Access Compliance Report Public Rights-of-Way (Curb Ramps)

Main Street: FOSTER_RD Cross Street: MAINWAY_DR Location: NE

ADA ID: RPRK211209121458 Ramp Type: Type 1 - Perpendicular Diagonal Initial Pass/Fail: Fail Overall Compliance: No Severity Score: 2

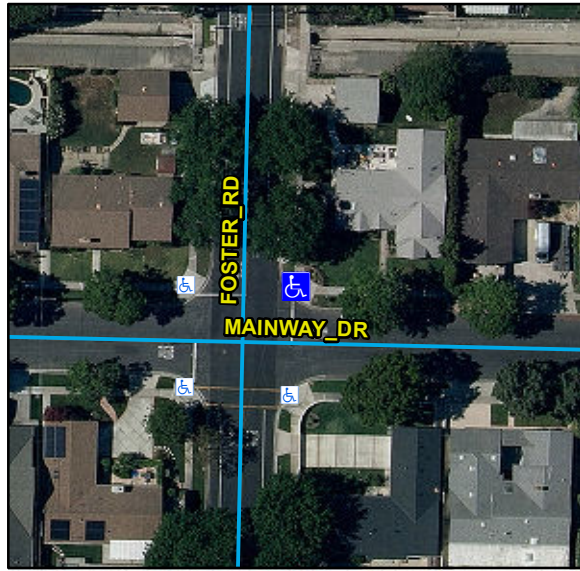
R204.3, R304.5.3, STD 1115

Remove & Replace Curb Ramp With Two New Directional Ramps or Equivalent.
